THE HIGHLINE AT UNION MARKET

320 FLORIDA AVENUE, N.E.
WASHINGTON DC

May 01, 2016
PUD MINOR MODIFICATION FOR PUD 15-01

BUILDING ELEVATION: SOUTH - *PROPOSED*

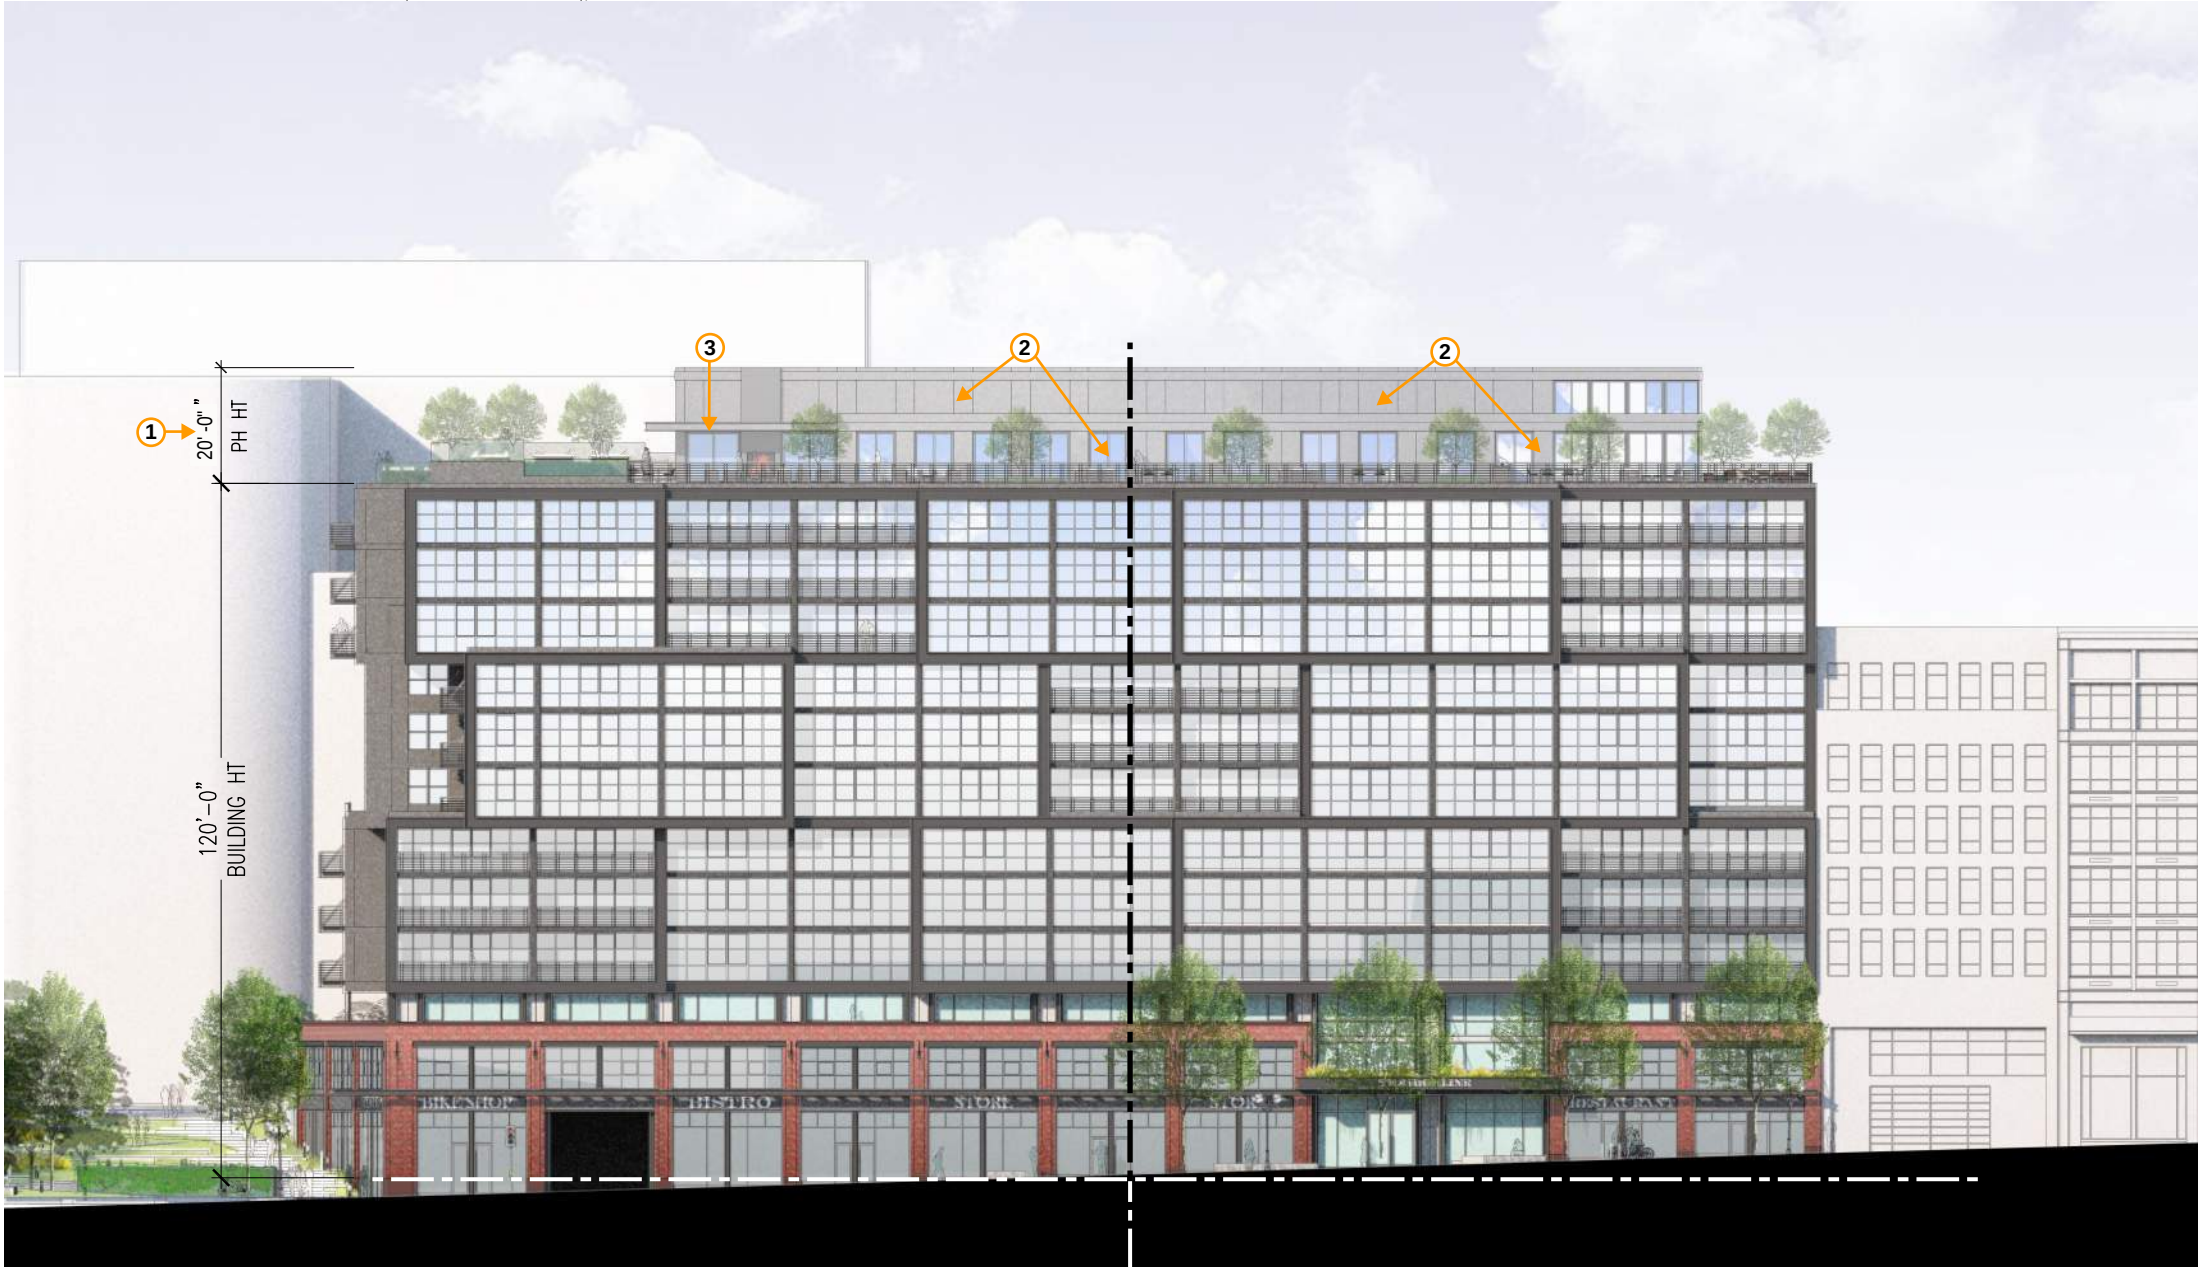
* CHANGES TO ROOF STRUCTURE TO INCORPORATE ZC ORDER NO. 14-13

- 1. PENTHOUSE HEIGHT NOW 20'
- 2. WINDOW /LOUVER CHANGES
- 3. NEW TRELLIS

BUILDING ELEVATION: EAST - *PROPOSED*

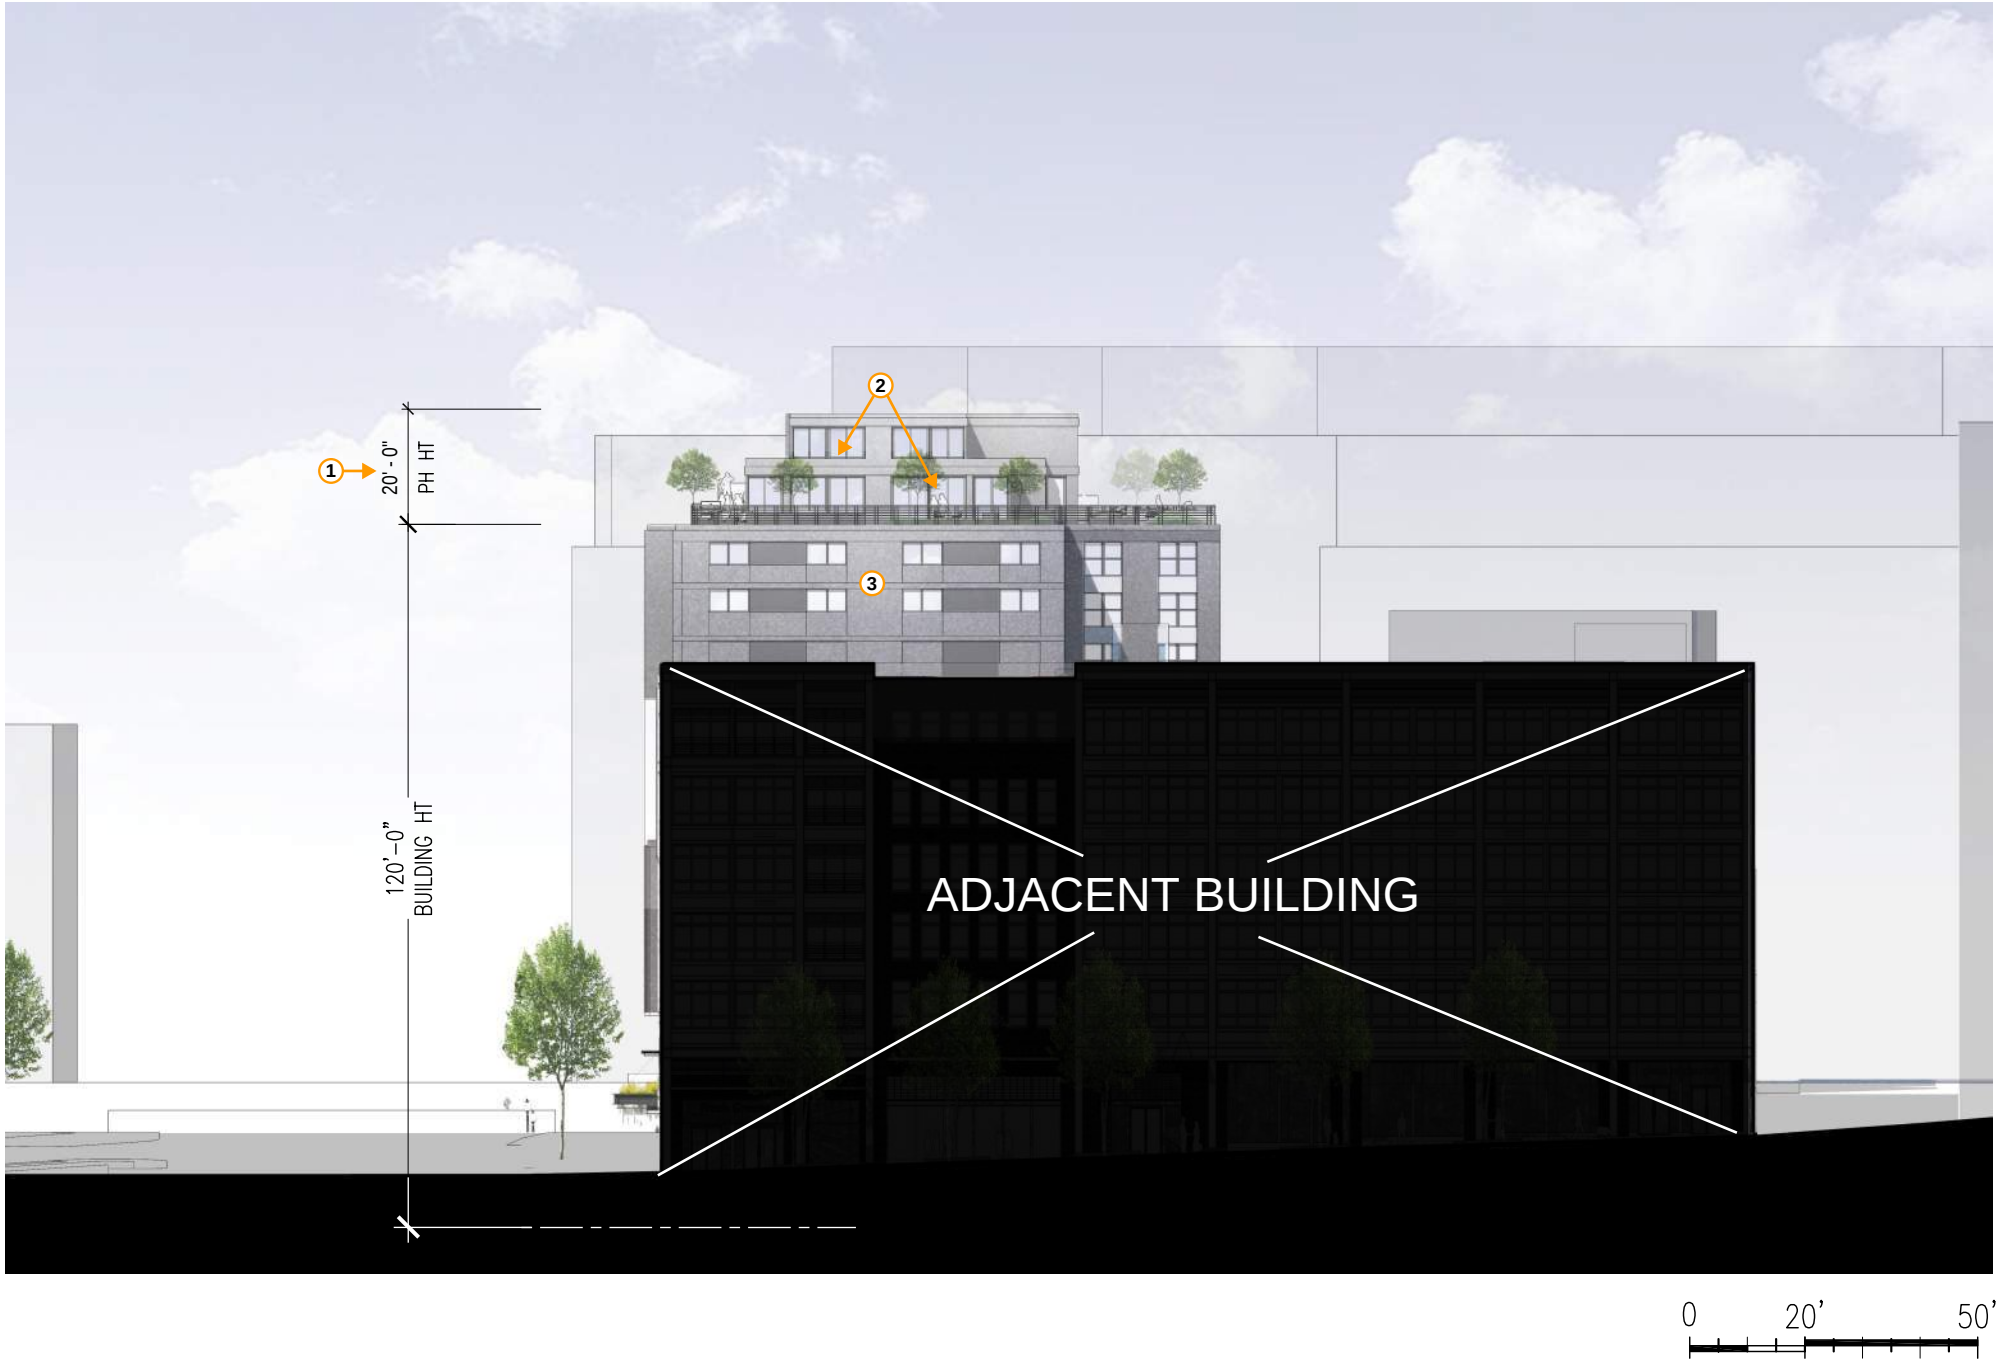
- CHANGES TO ROOF STRUCTURE TO
* INCORPORATE ZC ORDER NO. 14-13
1. PENTHOUSE HEIGHT NOW 20'

2. NEW WINDOWS

3. FACADE DESIGN IMPROVEMENT

ROOFTOP BUILDING SECTIONS - *PROPOSED*

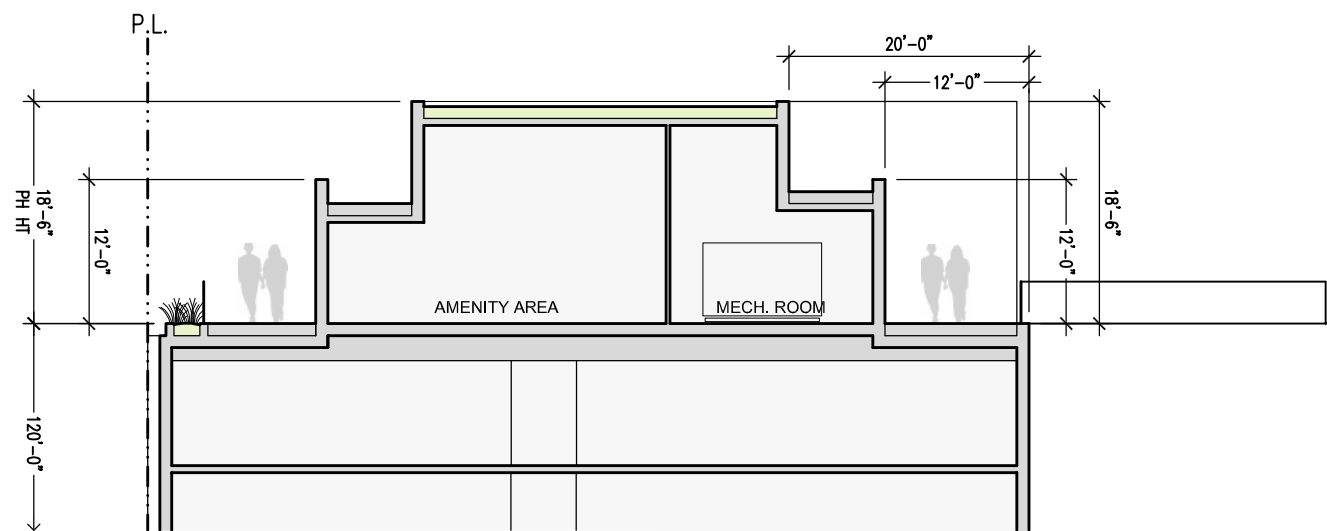
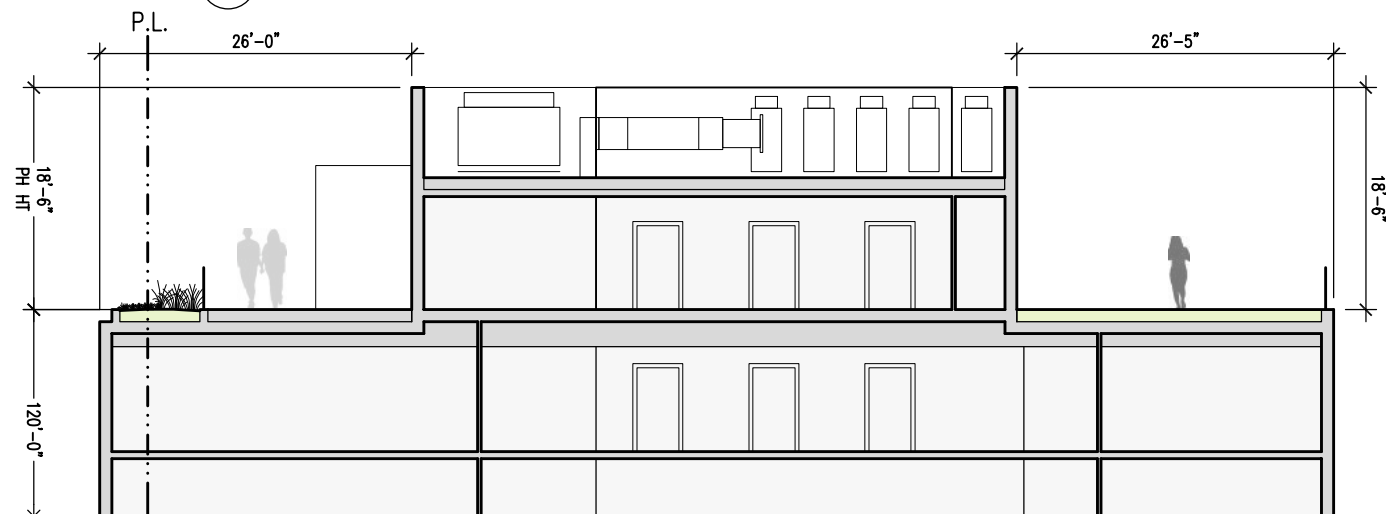
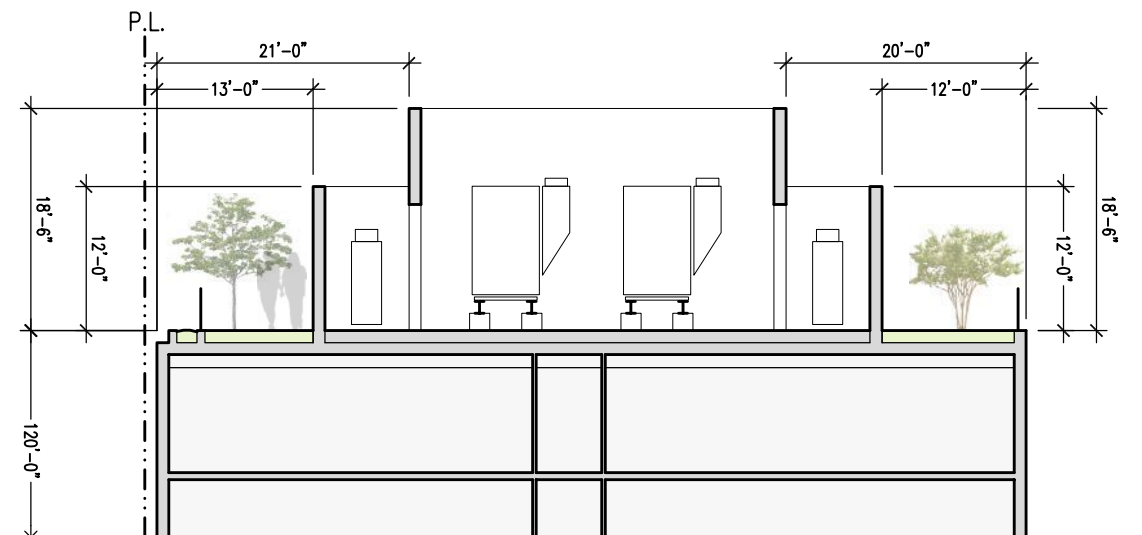
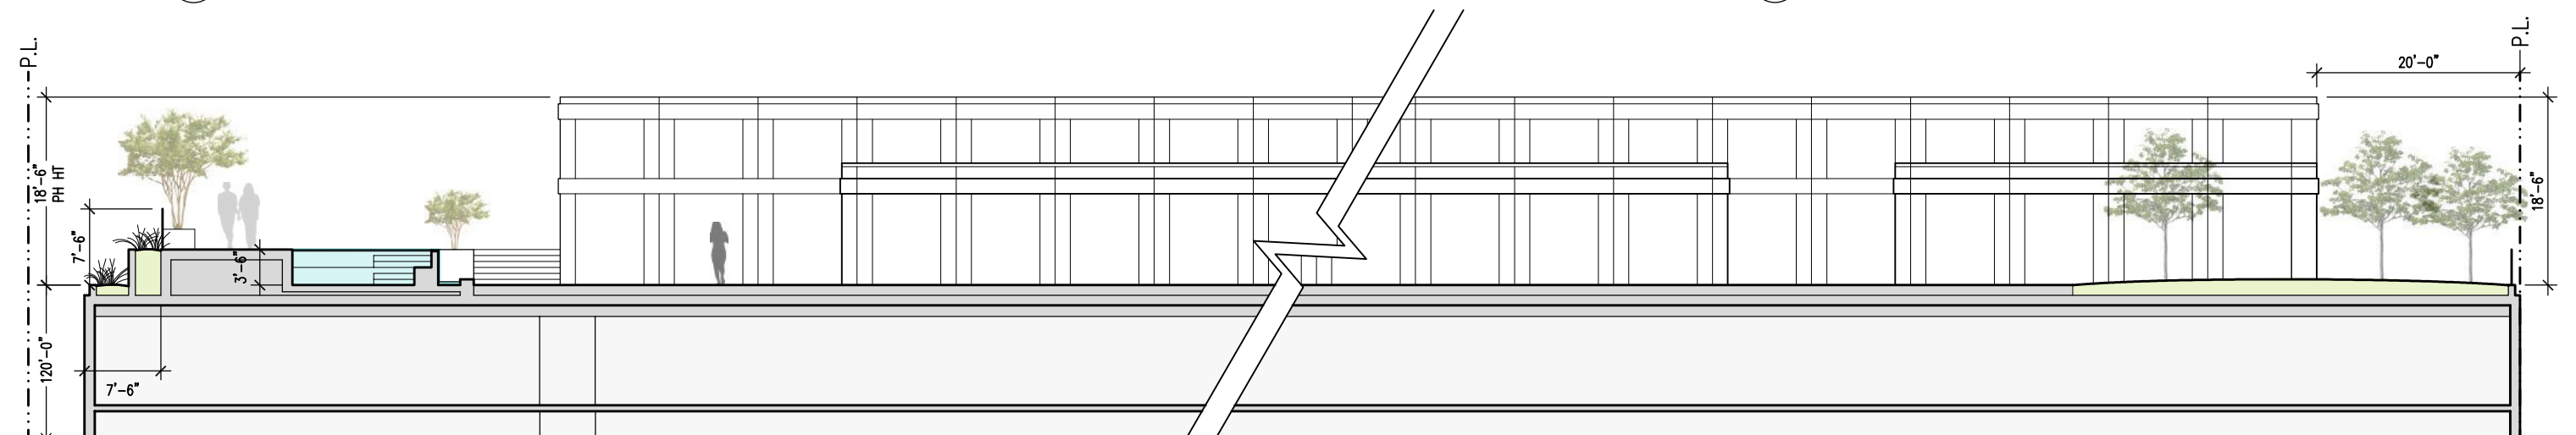
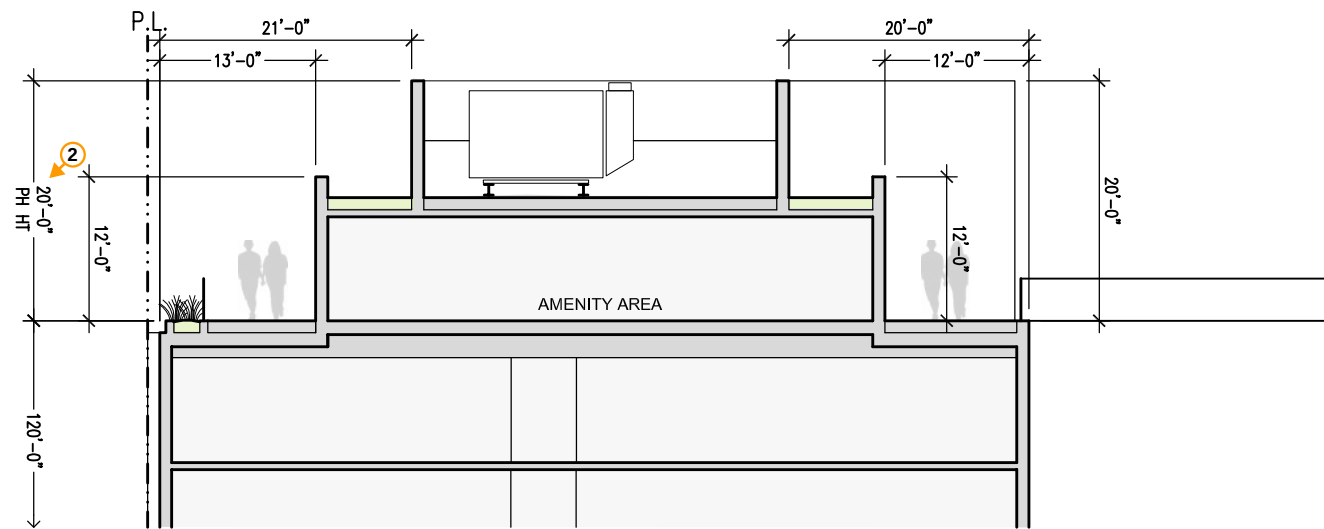
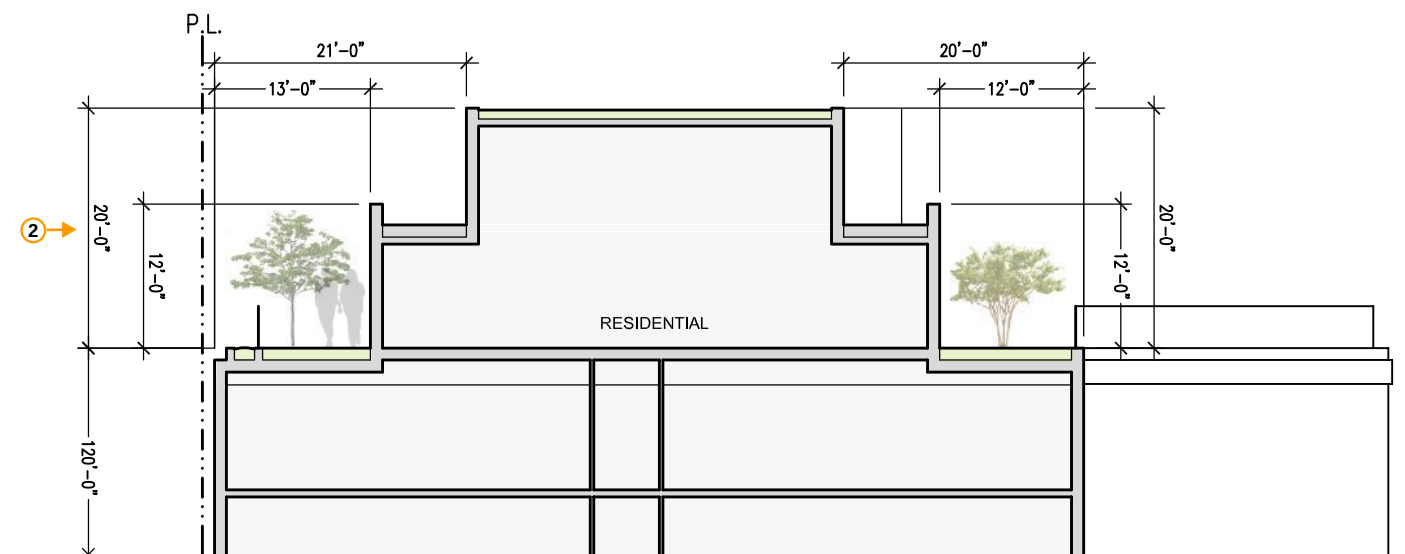
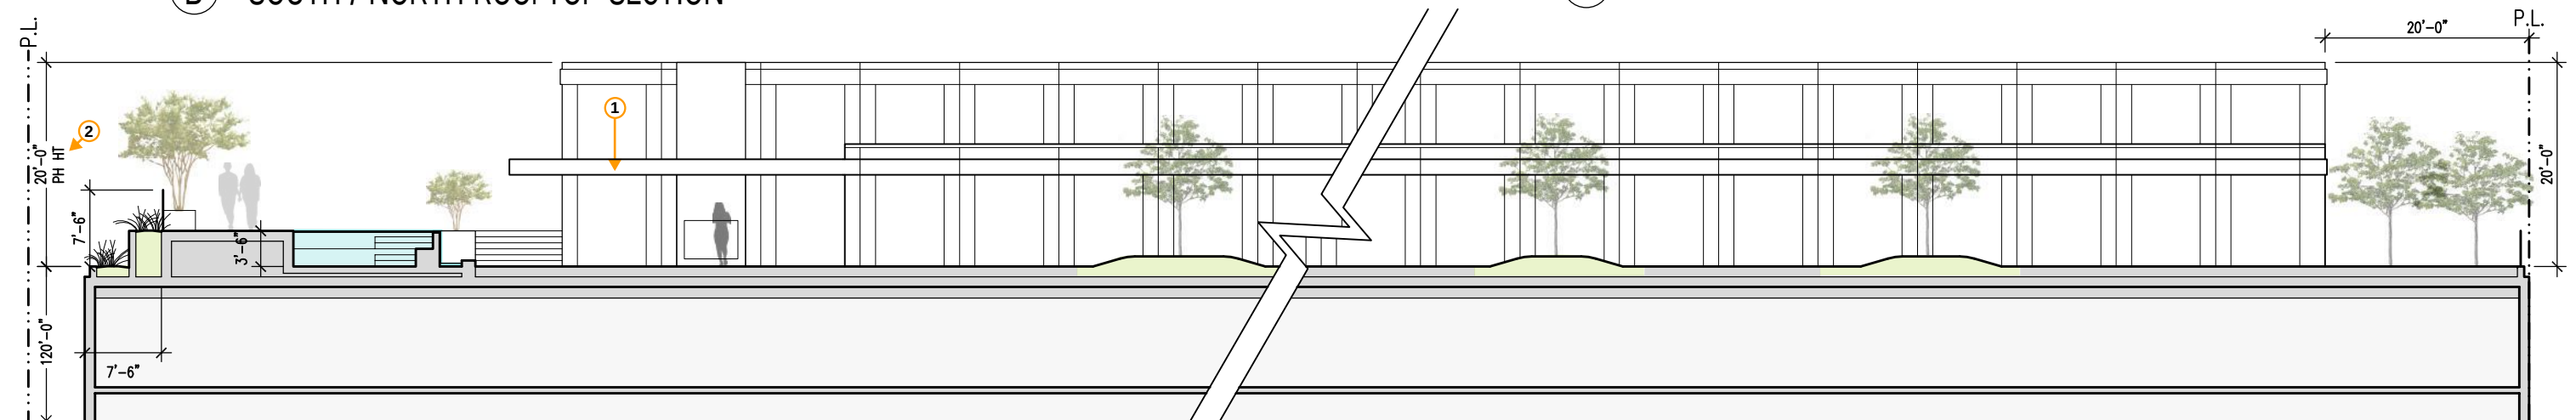
* CHANGES TO ROOF STRUCTURE TO INCORPORATE ZC ORDER NO. 14-13

1. NEW TRELLIS
2. PENTHOUSE HEIGHT NOW 20'
